Product Change Notification: E-18-006310

ASSEMBLY BATTERY CONNECTOR, SURFACE MOUNT, TOP LOAD

Document clarification for Top load button type battery connector

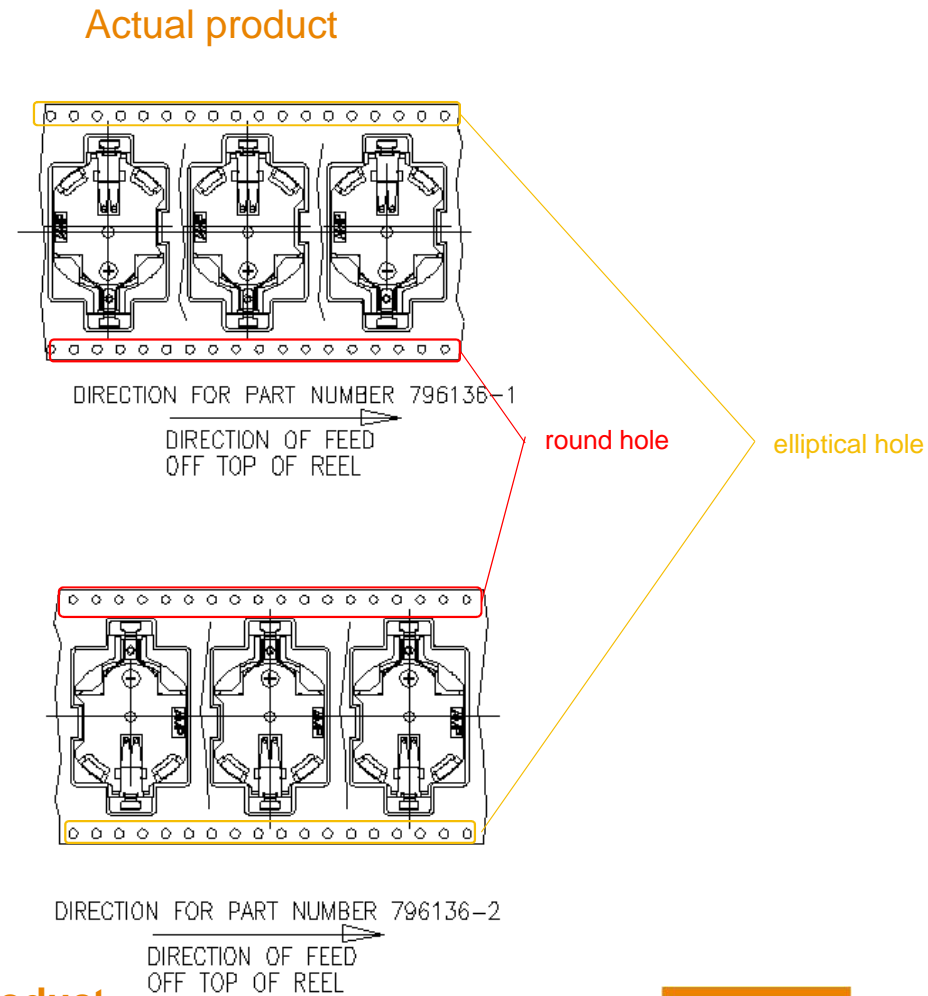
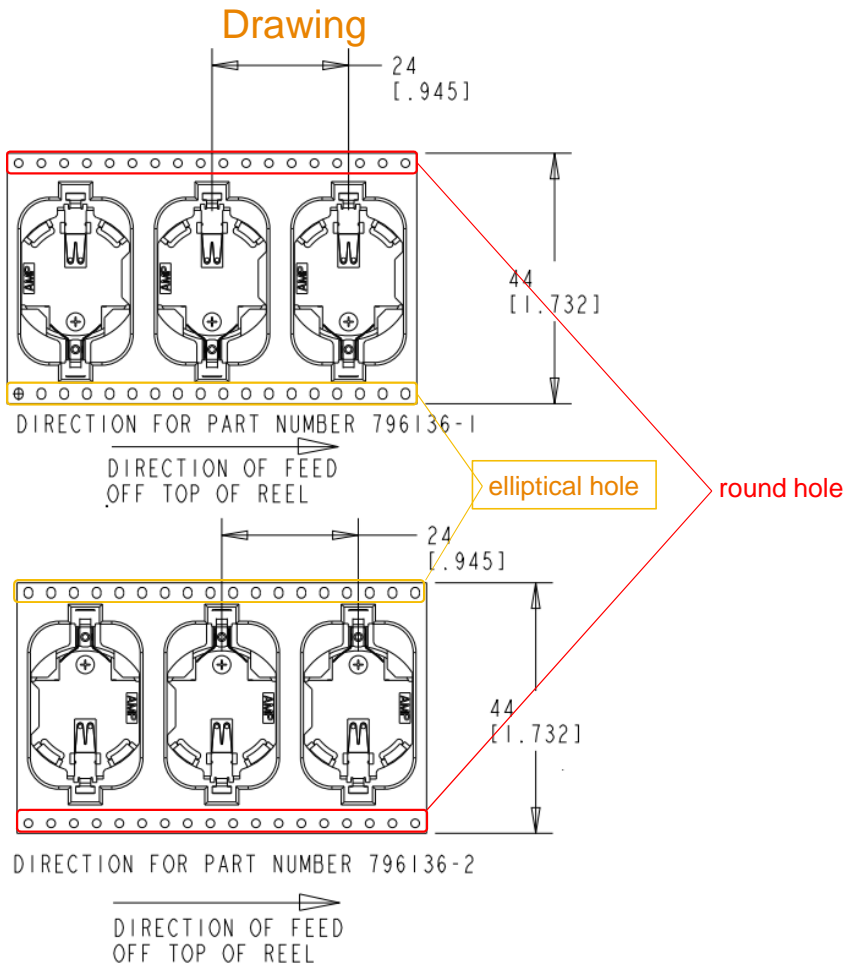
update emboss tape, detail as attachment

Document Clarification. The location hole of emboss tape on drawing is not comfort to actual product.

TE will update drawing to match actual product.
